L-PI-15-0014  
10 CFR 50.55a

Prairie Island Nuclear Generating Plant Units 1 and 2  
Dockets 50-282 and 50-306  
Renewed License Nos. DPR-42 and DPR-60

Supplement to 10 CFR 50.55a Requests (RR) 1-RR-5-1 and 2-RR-5-1 (TACs MF4833 and MF4834) Associated with Prairie Island Nuclear Generating Plant (PINGP) Fifth Ten-Year Interval Inservice Inspection (ISI) Program

### **Supplement to 10 CFR 50.55a Requests (RR) 1-RR-5-1 and 2-RR-5-1 Associated with Prairie Island Nuclear Generating Plant (PINGP) Fifth Ten-Year Interval Inservice Inspection (ISI) Program**

Figure 1

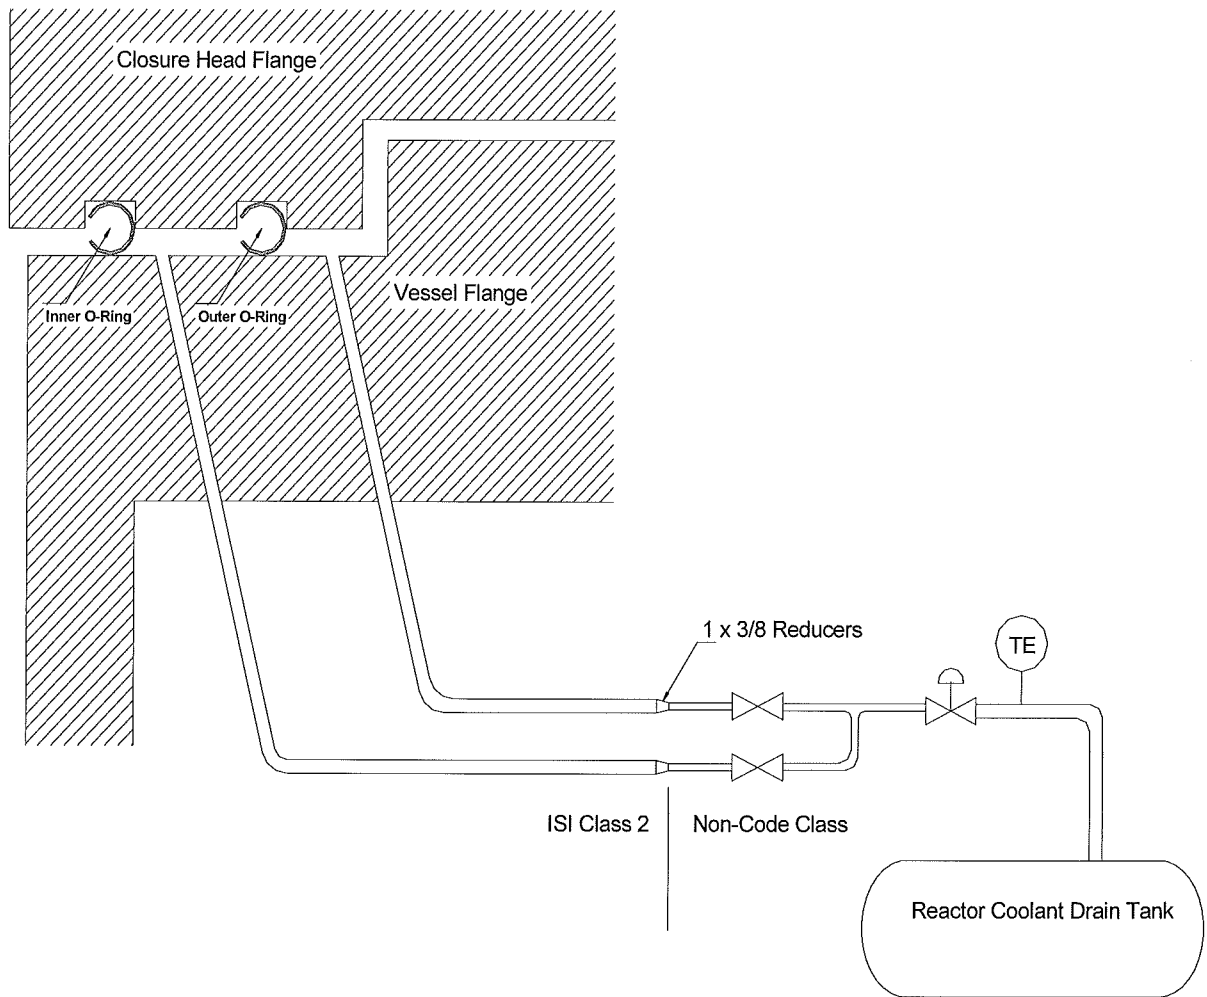
Provide a detailed diagram of the RPV head flange seal leak-off lines piping and identify clearly in the diagram the boundary for which the IWB-5222(b) requirement apply and is covered by this relief request.

The leak-off lines consist of two 1 inch (nominal pipe size) NPS lines piped to a common temperature element. One line originates from the space between the two concentric reactor vessel closure head O-rings. The other line originates from outside the second reactor vessel closure head O-ring. The purpose of the lines is to provide

control room indication of reactor closure head O-ring leakage and to direct leakage to the reactor coolant drain tank RCST). The boundary covered by this request is from the reactor vessel flange to the 1 x 3/8 inch reducers as shown on Figure 1 below. NSPM decided to treat the leak-off lines as American Society of Mechanical Engineers (ASME) Section XI Class 1, although the site process flow diagrams indicate they are Class 2.
